**Nomination Form
Anadromous Waters Catalog**

Anadromous Waters Catalog Number of Water Body 242-31-10120 (-2149)

Name of Water Body Rocky River USGS Name Local Name

Nomination #	<u>25-888</u>	<u>[Signature]</u>	<u>12/26/2025</u>
		Fisheries Scientist	Date
Revision Year:	<u>2026</u>	<u>[Signature]</u>	<u>12/24/25</u>
		Habitat Operations Manager	Date
Revision to:	<input checked="" type="checkbox"/> Atlas <input checked="" type="checkbox"/> Catalog	<u>[Signature]</u>	
		AWC Project Biologist	Date
Revision Code:	<u>C-9, C-7, B-6, B-2</u>	<u>P.C.</u>	<u>12/31/2025</u>
		GIS Analyst	Date

Map # 1

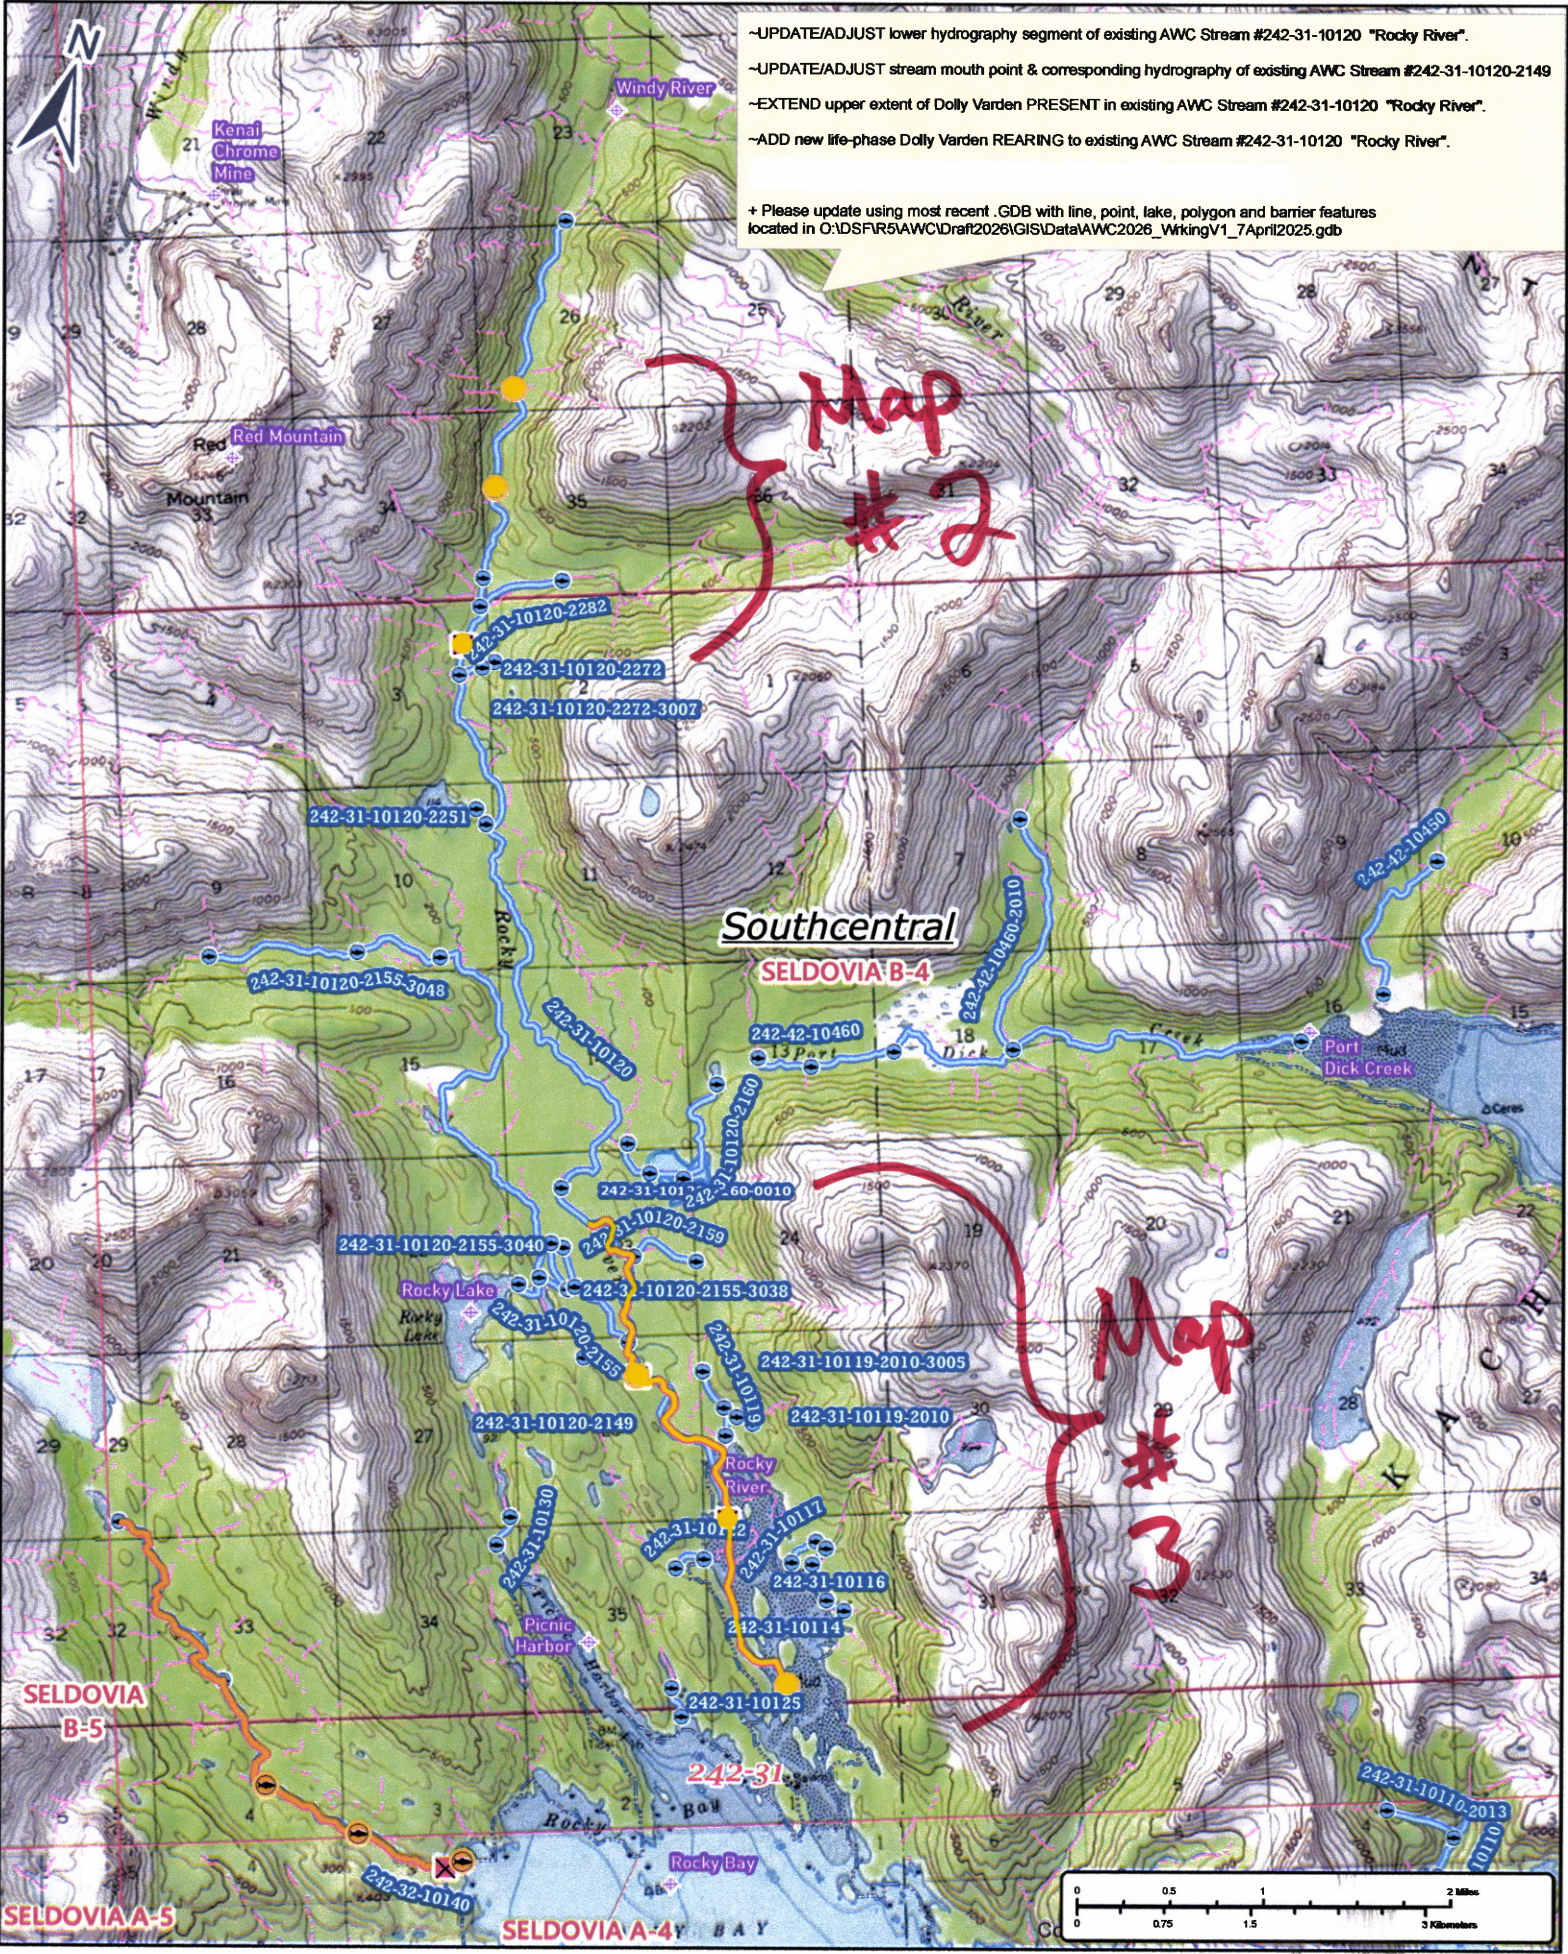
- UPDATE/ADJUST lower hydrography segment of existing AWC Stream #242-31-10120 "Rocky River".
 - UPDATE/ADJUST stream mouth point & corresponding hydrography of existing AWC Stream #242-31-10120-2149
 - EXTEND upper extent of Dolly Varden PRESENT in existing AWC Stream #242-31-10120 "Rocky River".
 - ADD new life-phase Dolly Varden REARING to existing AWC Stream #242-31-10120 "Rocky River".
- + Please update using most recent .GDB with line, point, lake, polygon and barrier features located in O:\DS\FR5\AWC\Draft2026\GIS\Data\AWC2026_WorkingV1_7April2025.gdb

Map # 2

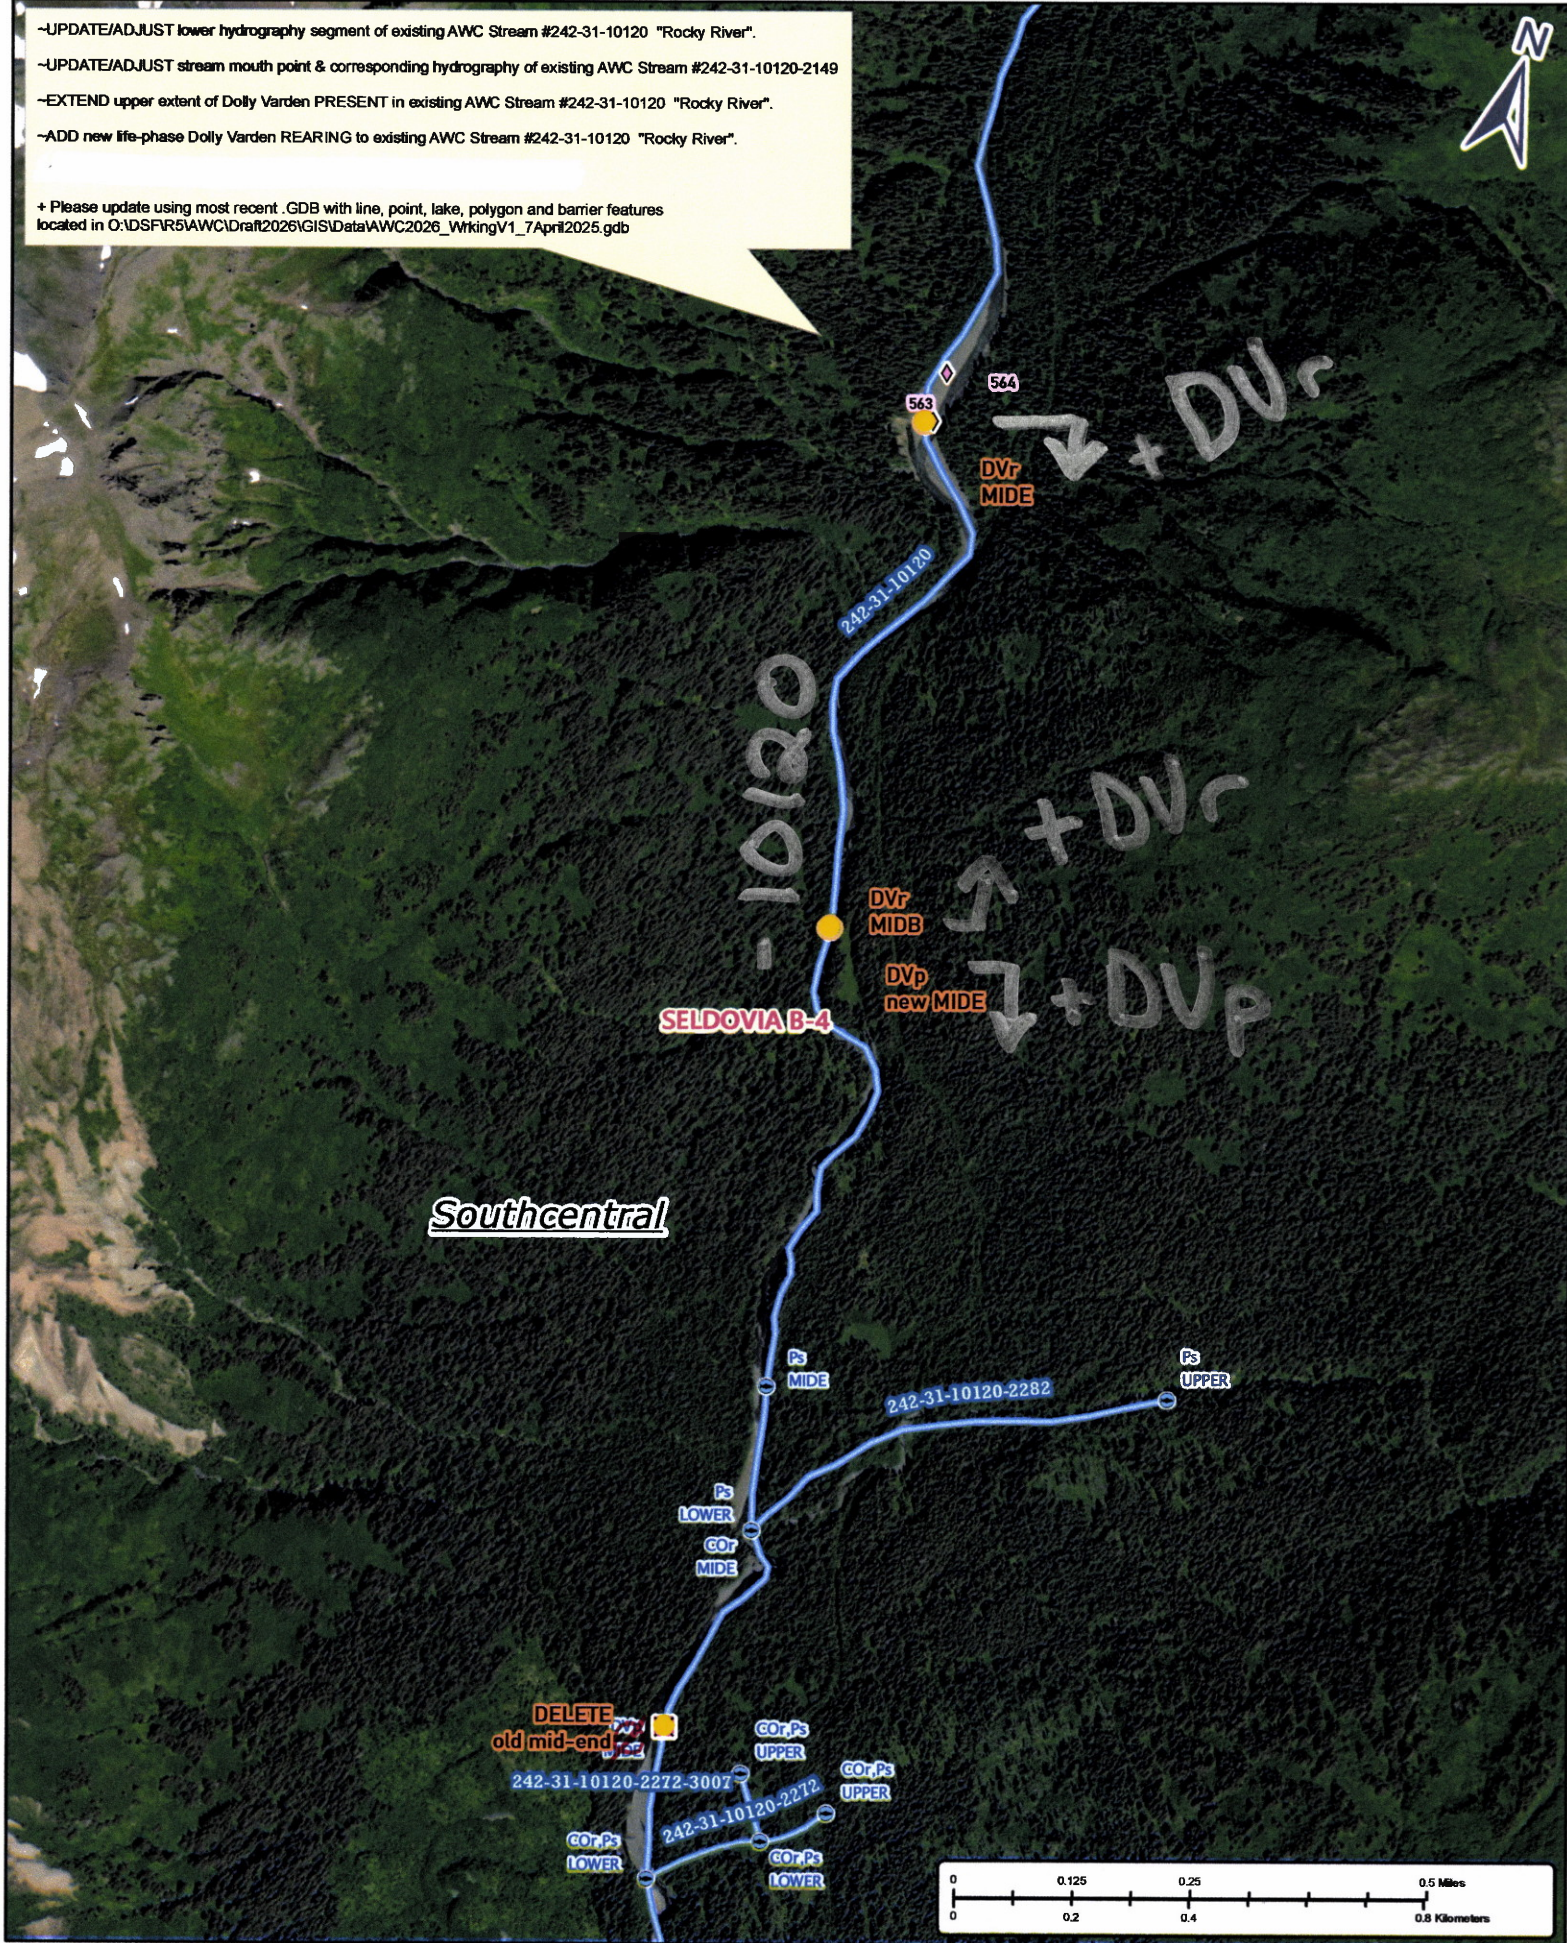
- UPDATE/ADJUST lower hydrography segment of existing AWC Stream #242-31-10120 "Rocky River".
- UPDATE/ADJUST stream mouth point & corresponding hydrography of existing AWC Stream #242-31-10120-2149
- EXTEND upper extent of Dolly Varden PRESENT in existing AWC Stream #242-31-10120 "Rocky River".
- ADD new life-phase Dolly Varden REARING to existing AWC Stream #242-31-10120 "Rocky River".

+ Please update using most recent .GDB with line, point, lake, polygon and barrier features located in O:\DSFR5AWC\Draft2026\GIS\Data\AWC2026_WrkingV1_7April2025.gdb

Map #4

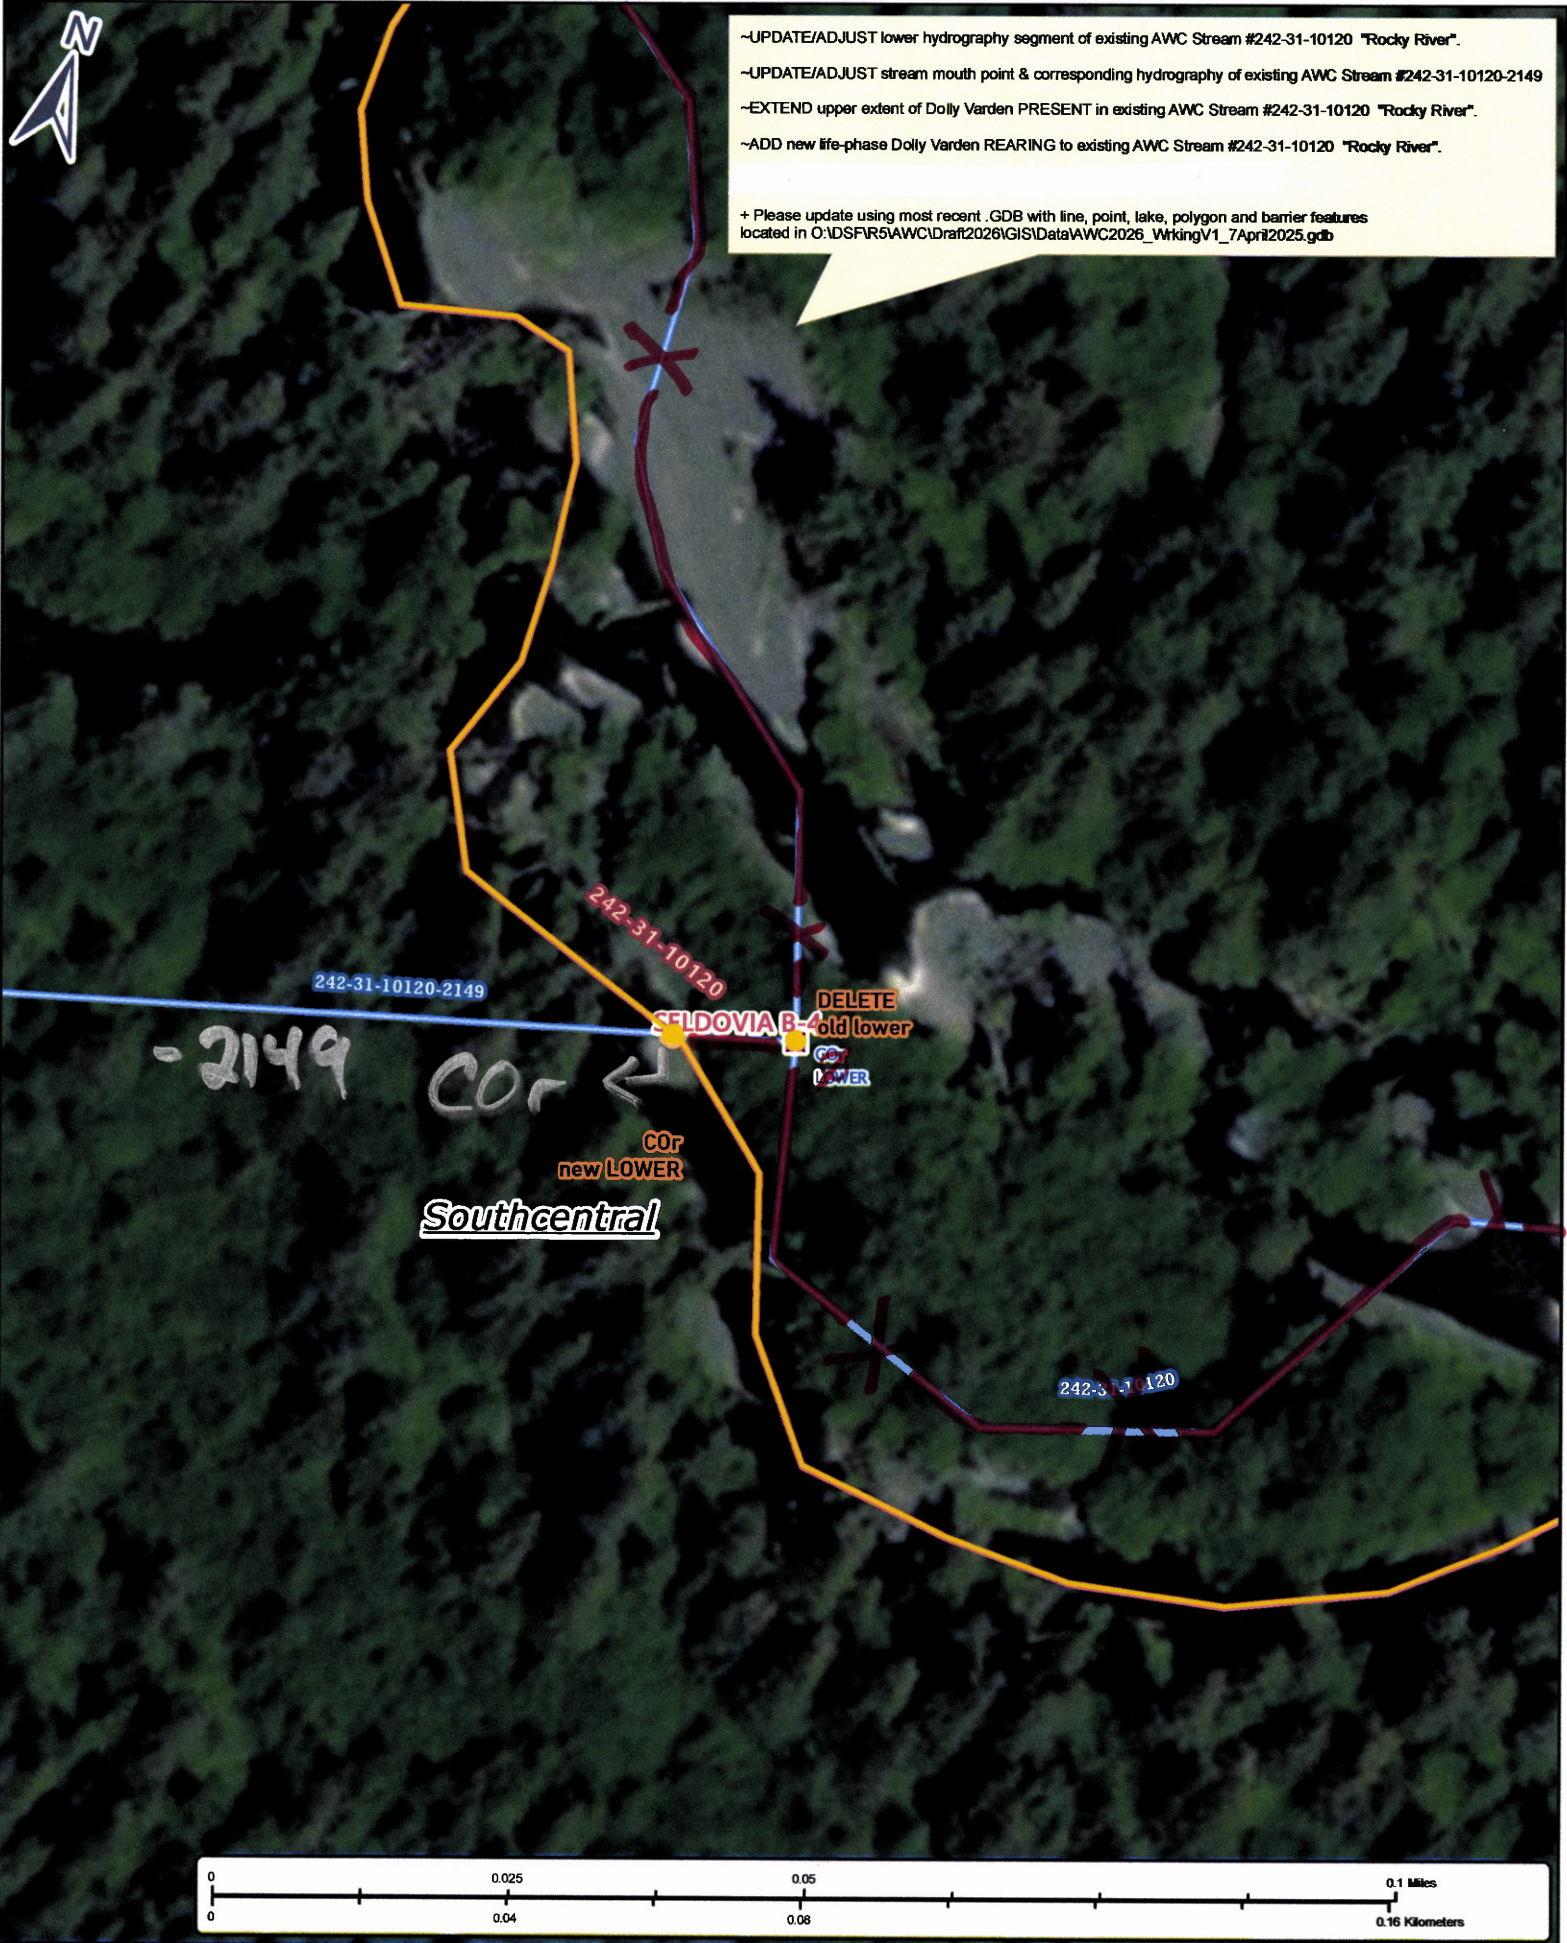
-UPDATE/ADJUST lower hydrography segment of existing AWC Stream #242-31-10120 "Rocky River".
 -UPDATE/ADJUST stream mouth point & corresponding hydrography of existing AWC Stream #242-31-10120-2149
 -EXTEND upper extent of Dolly Varden PRESENT in existing AWC Stream #242-31-10120 "Rocky River".
 -ADD new life-phase Dolly Varden REARING to existing AWC Stream #242-31-10120 "Rocky River".
 + Please update using most recent .GDB with line, point, lake, polygon and barrier features located in O:\DSFR5AWC\Draft2026\GIS\Data\AWC2026_WrkingV1_7April2025.gdb

COR ←

COR
new LOWER

DELETE
old lower

COR
LOWER
